Architect's Supplemental Instructions

Architect's ASI No: 053

Project:
Webster University
Interdisciplinary Science
Building

Date Issued: 02/24/2017

LEVEL 02 AREA B FLOOR
PLAN - ELECTRICAL &
AUXILIARY

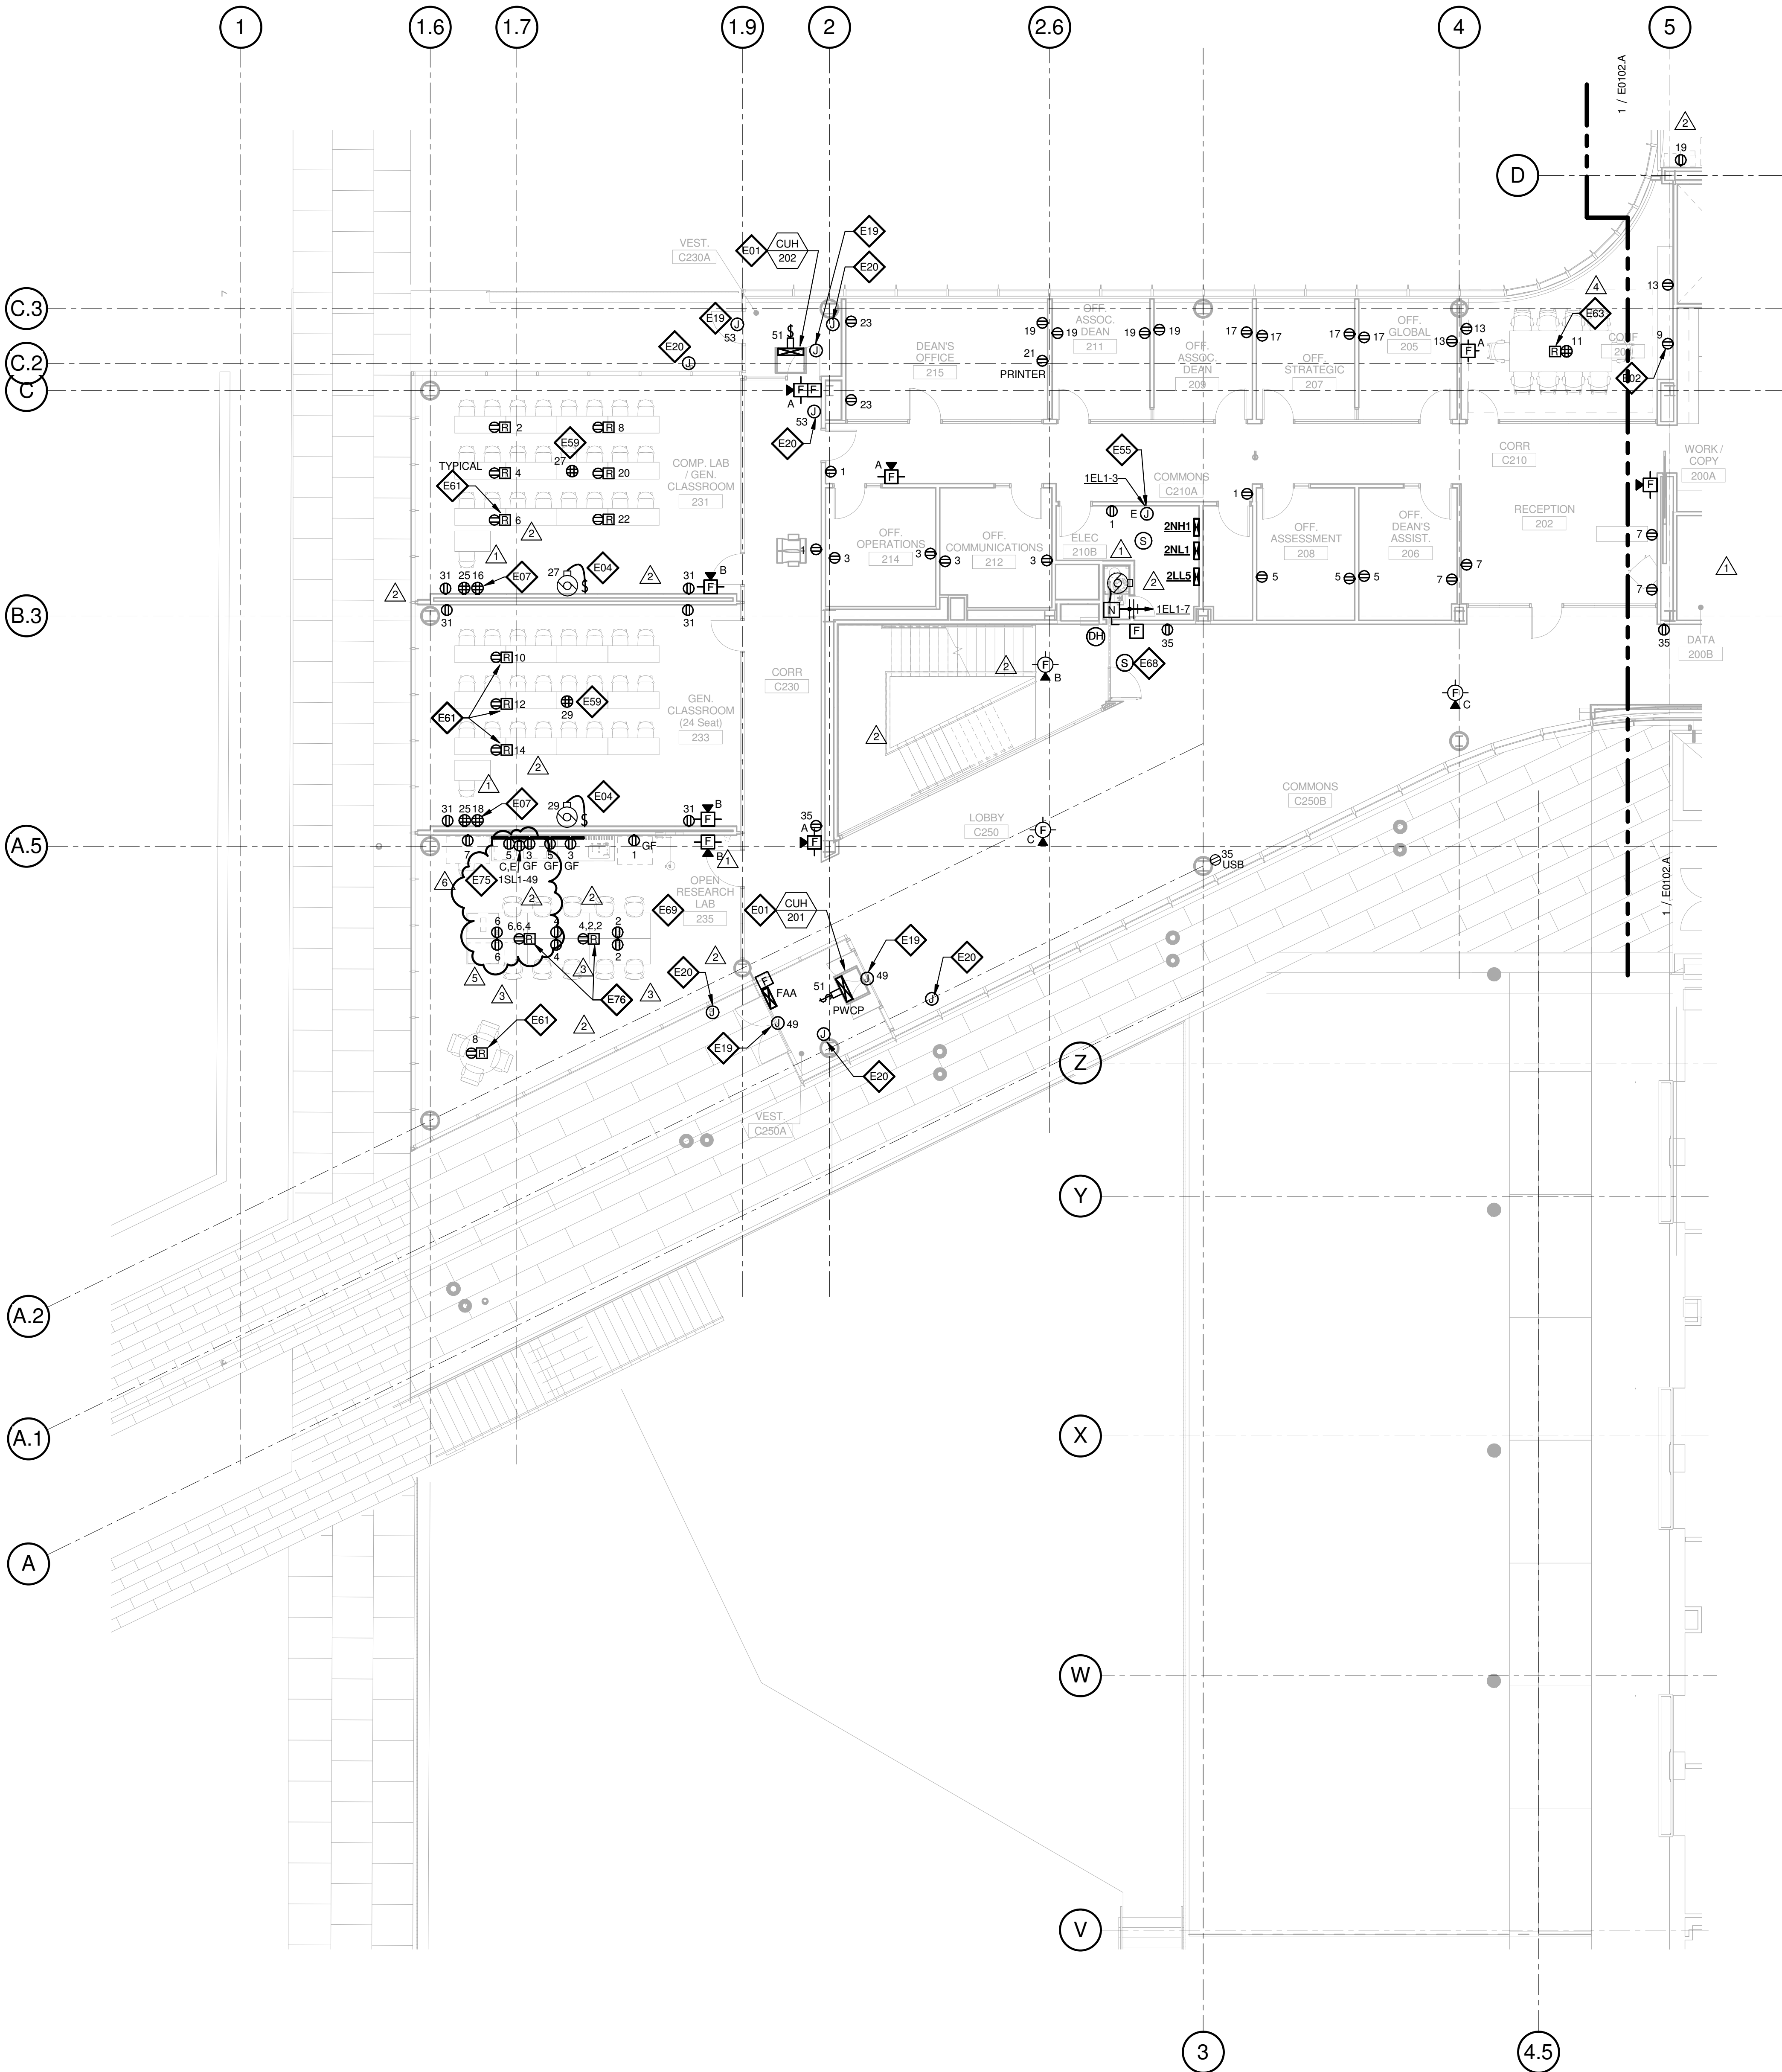
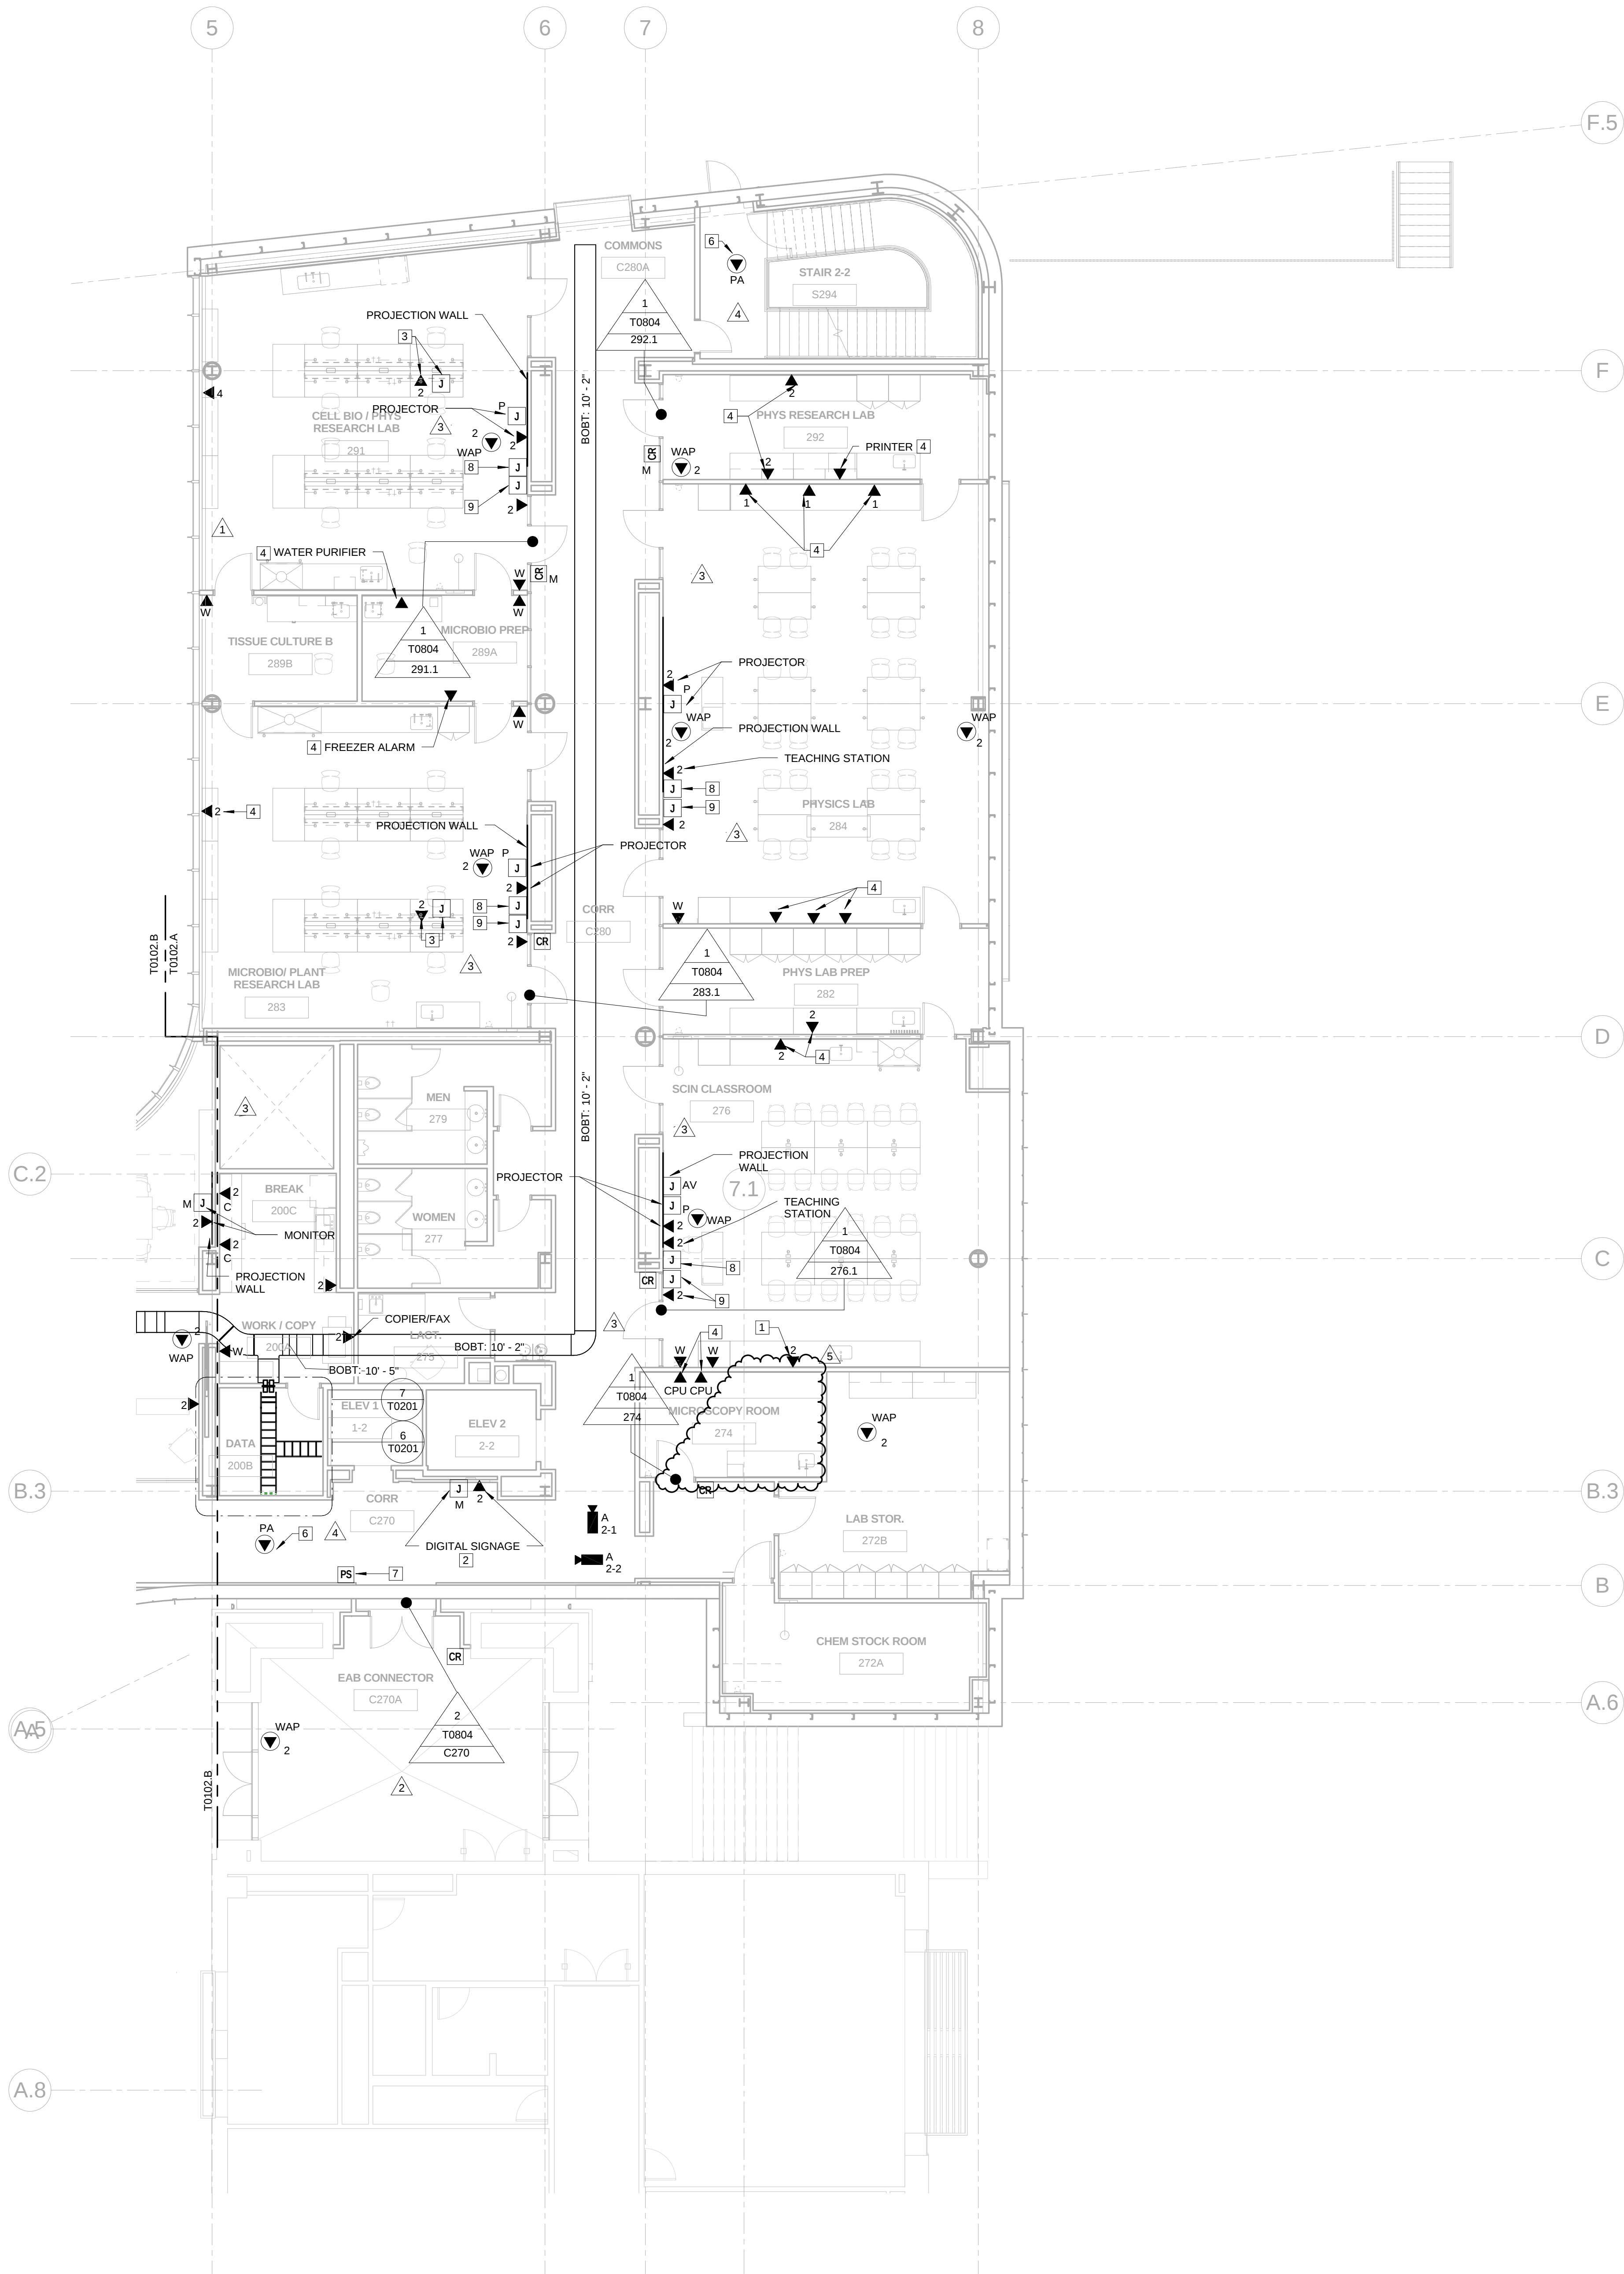
- In Open Research Lab 235, delete emergency circuit from floor box and lab table. Add horizontally mounted duplex receptacle above counter and connect to circuit 1SL1-49 previously floor box.

LEVEL 02 FLOOR PLAN - AREA A

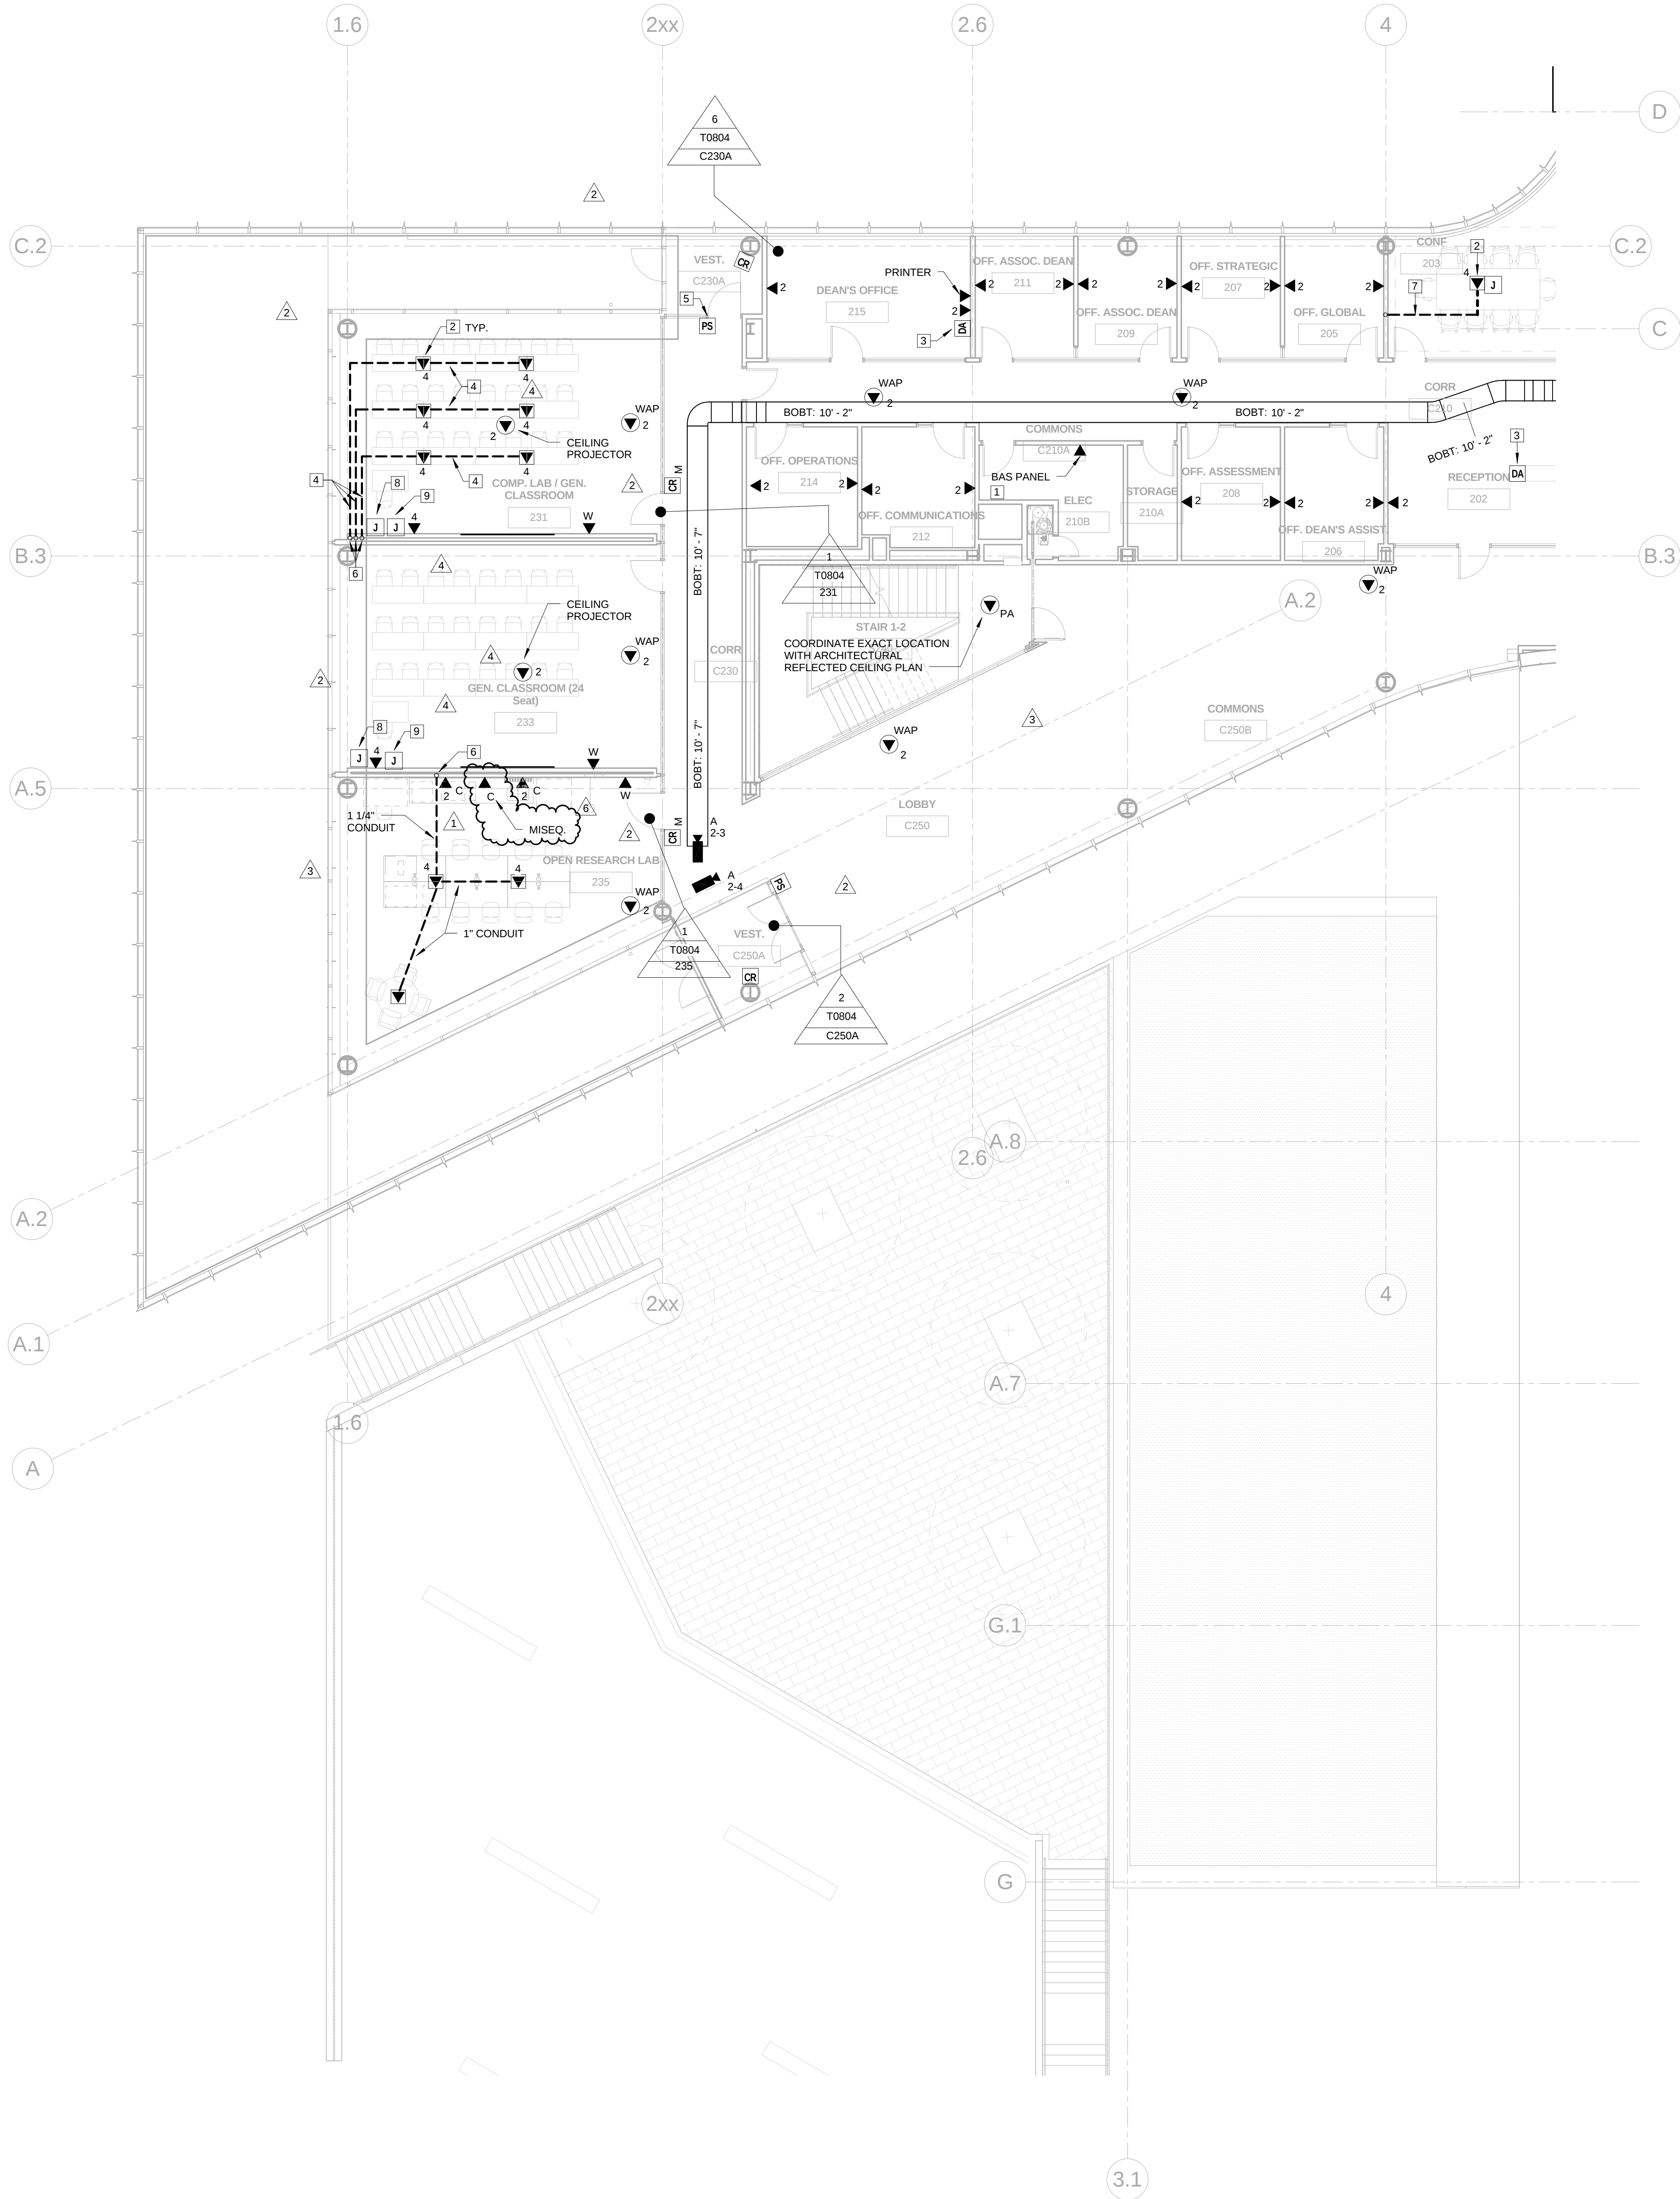
- Delete data connections for Gel Doc CPU and Biorad Gel Dock in Microscopy Room 274.
